Access Compliance Report

Public Rights-of-Way

Intersection ID: 10035429	Main Street: RANDOLPH_RD	Cross Street: N/A	Location: SW
ADA ID: 5D1AE2E92CCB	Ramp Type: PerpDiag	Initial Pass/Fail: Fail	Overall Compliance: No
		Severity Score: 12.5

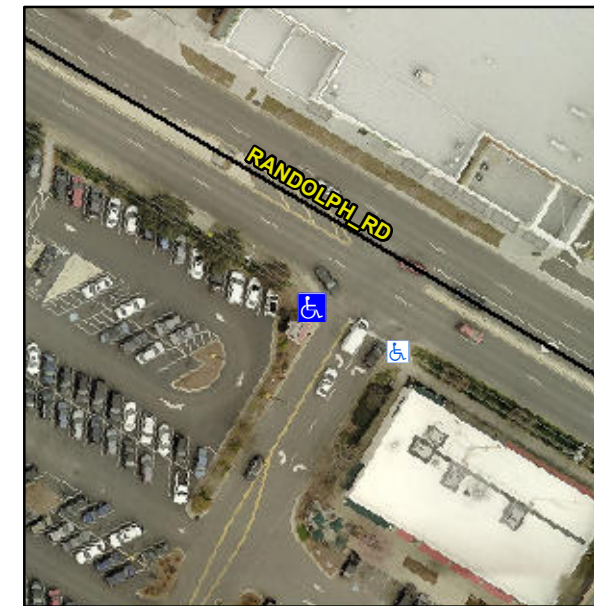
Not Found, R304.5.3

Compliance	Description	Data	Compliance	Description	Data
N/A	Ramp Length (in)	107.0	Yes	Ramp Slope (%)	6.3
Yes	Ramp Width (in)	51.0	No	Ramp XSlope (%)	5.1
N/A	Flare Type LT	N/A	N/A	Flare Type RT	N/A
N/A	Flare Slope LT (%)	N/A	N/A	Flare Slope RT (%)	N/A
N/A	Flare Traversable LT?	N/A	N/A	Flare Traversable RT?	N/A
N/A	Landing Length (in)	N/A	N/A	DWS Provided?	N/A
N/A	Landing Width (in)	N/A	N/A	DWS Contrast?	N/A
N/A	Landing Slope (%)	N/A	N/A	DWS Length (in)	N/A
N/A	Landing X Slope (%)	N/A	N/A	DWS Full Width?	N/A
N/A	Landing Curb? (Y/N)	N/A	N/A	DWS Offset (in)	N/A
N/A	Shared Landing?	N/A			
N/A	Gutter Ponding?	N/A	N/A	Gutter Slope (%)	N/A
N/A	Gutter Lip Ht (in)	N/A	N/A	Gutter X Slope (%)	N/A
N/A	Painted X Walk1?	No	N/A	Painted X Walk2?	No
	X Walk 1 Direction	To SE		X Walk 2 Direction	To NE
N/A	X Walk 1 Width (in)	N/A	N/A	X Walk 2 Width (in)	N/A
	X Walk 1 Slope (%)	1.7		X Walk 2 Slope (%)	2.6
	X Walk 1 X Slope (%)	0.3		X Walk 2 X Slope (%)	1.2

Remove & Replace Curb Ramp With Two New Directional Ramps or Equivalent.
